PLANNING AND ZONING AND COUNTY COUNCIL INFORMATION SHEET

Application: Pelican Point 4-5 (2019-30)

To: Sussex County Technical Advisory Committee
From: Christin Headley, Planning Technician
Date: December 19, 2019
RE: Major Subdivision

The following comments are the result of the Sussex County Engineering Department's review of the preliminary site plan for the above referenced project:

REVISED PRELIMINARY SUBDIVISION PLAT
FOR
PELICAN POINT 4-5
SUSSEX COUNTY, DELAWARE
FOR
CANNON ROAD INVESTMENTS, LLC

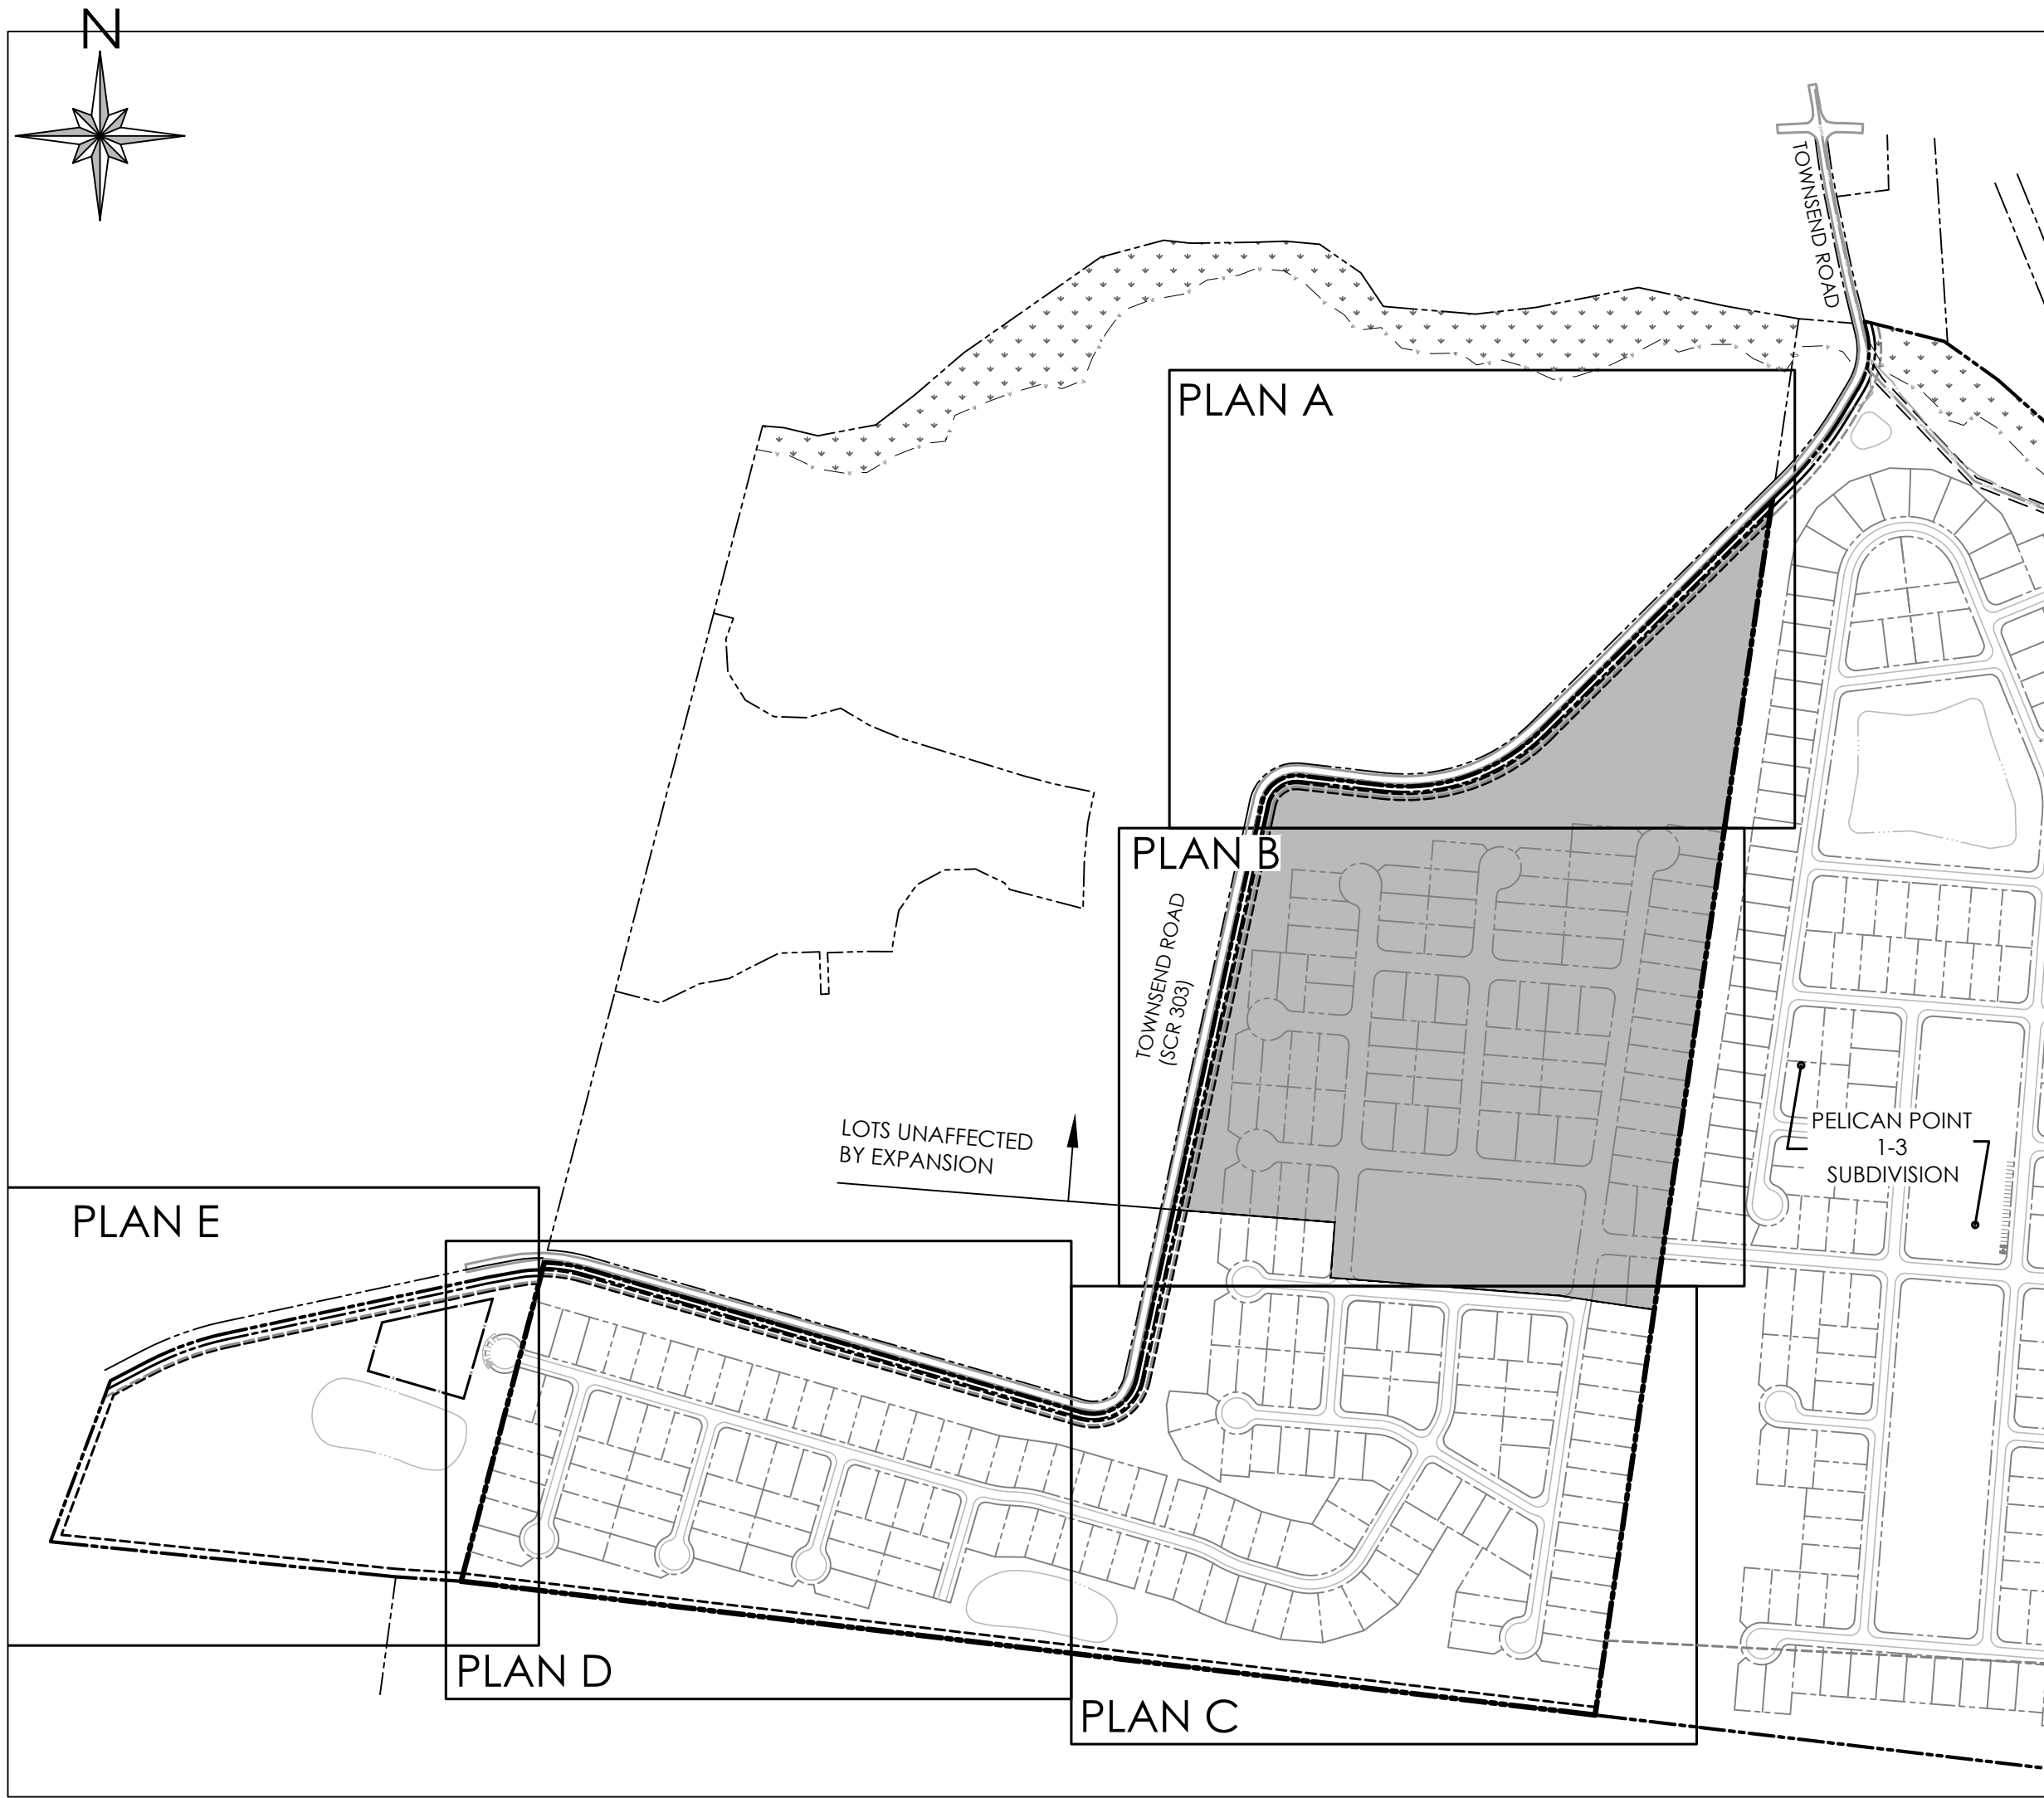
1. The proposed phase numbers conflict with existing phase numbers and must be modified to be consistent with the existing phasing plan on file with the Engineering Department.
